ADDENDUM #1

To: Prospective Bidders
From: Porter Co. Dept. of Development & Storm Water Management
Date: November 26, 2024
Subject: Olney Road Drainage Improvements

PORTER COUNTY DEPT. OF DEVELOPMENT & STORM WATER MANAGEMENT, INDIANA
OLNEY ROAD DRAINAGE IMPROVEMENTS

ADDENDUM NO. 1

EXISTING CONDITIONS AND DEMOLITION PLAN

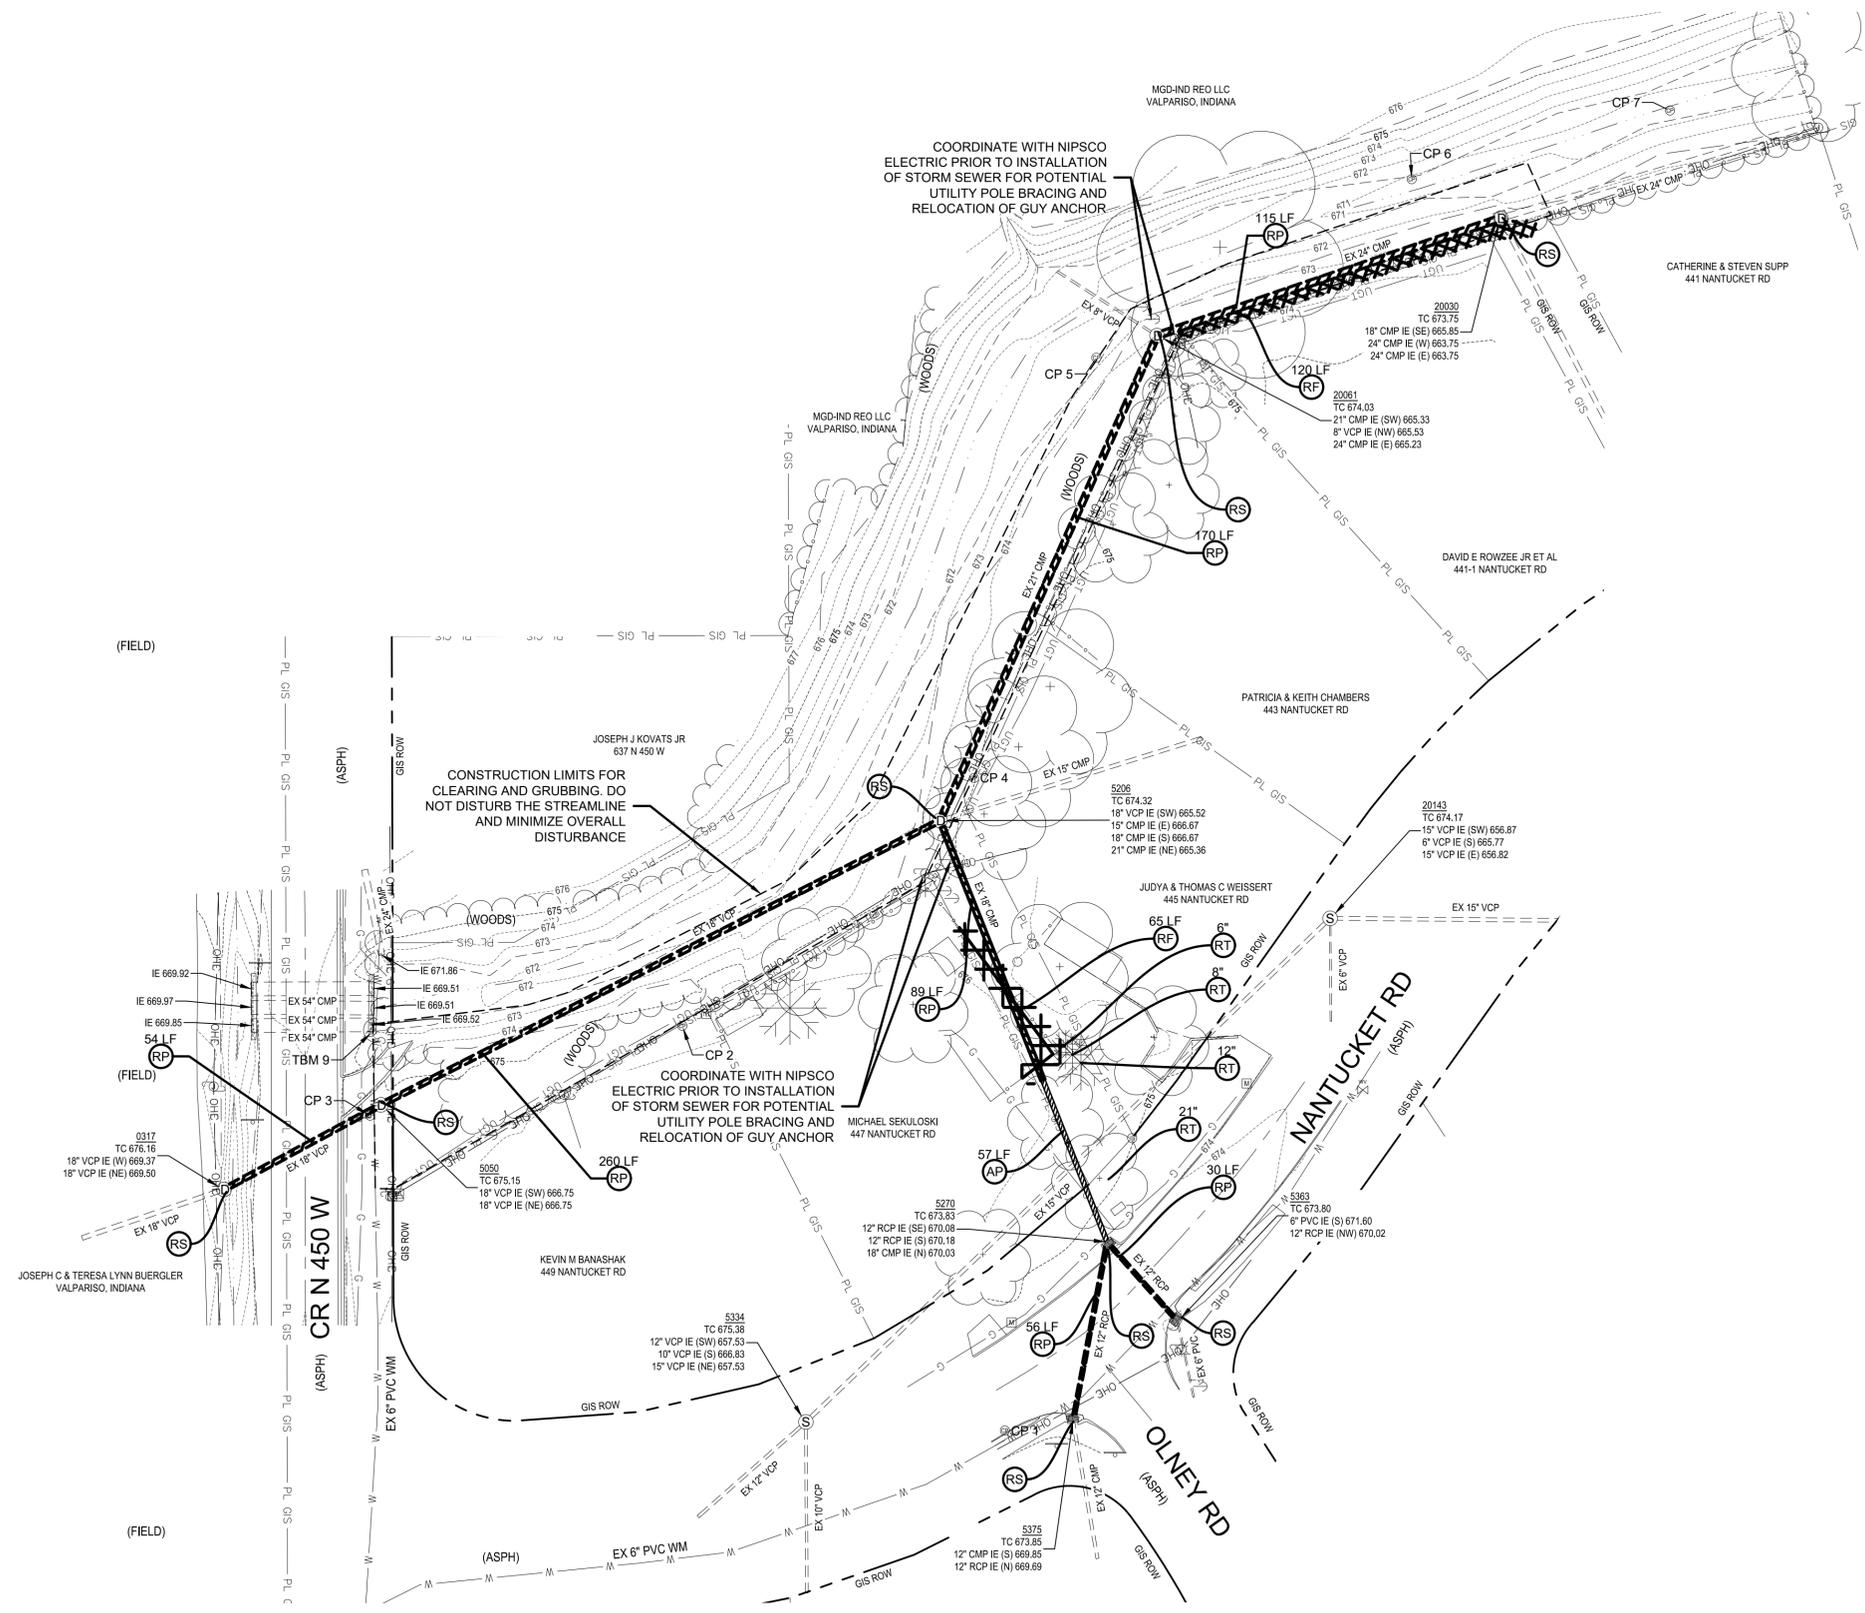
REPLACE Sheet No. 04 with the attached Sheet No. 04
AP specification in legend and keyed notes revised to flowable fill instead of non-shrink grout.

- RP REMOVE PIPE COMPLETELY
- RS REMOVE STRUCTURE
- RF REMOVE AND REINSTALL FENCE
- RT REMOVE TREE
- AP ABANDON PIPE WITH FLOWABLE FILL

ITEM	REVISION	APPROVED DATE	PORTER COUNTY, INDIANA STANDARD DRAWINGS
			ROAD CUT & REPAIR

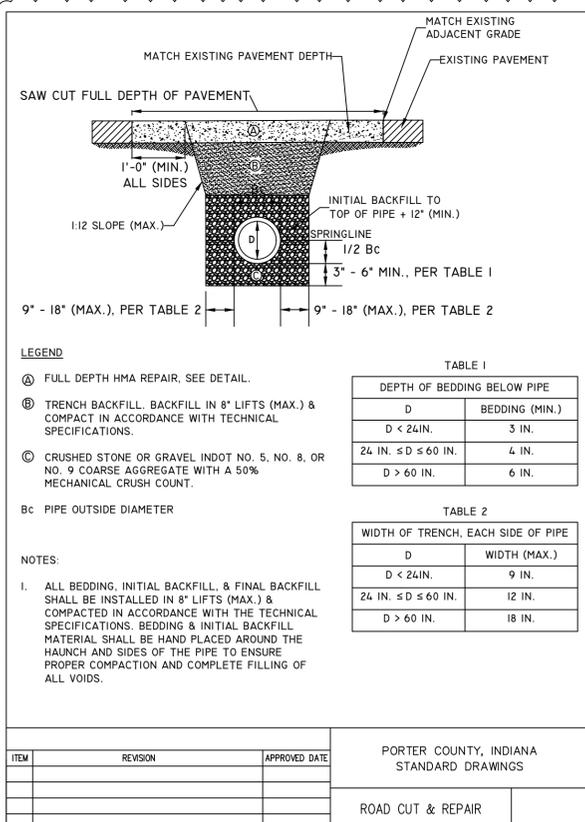
Q6: Detail VII-A2 on Plan Sheet 9: The detail calls for flowable fill under the road.

REPLACE Sheet No. 09 with the attached Sheet No. 09
“Pipe Bedding and Backfill Under Existing Pavement” detail replaced with updated “Road Cut and Repair” detail.

A3: *Flowable fill is not required. The Pipe Bedding and Backfill Under Existing Pavement has been updated per Attachment C – Clarifications and/or Modifications to this Addendum.*

A6: *This is incorrect. Flowable fill is not required, please use No. 53 Stone as shown in other details. The drawings will be updated via addendum.*
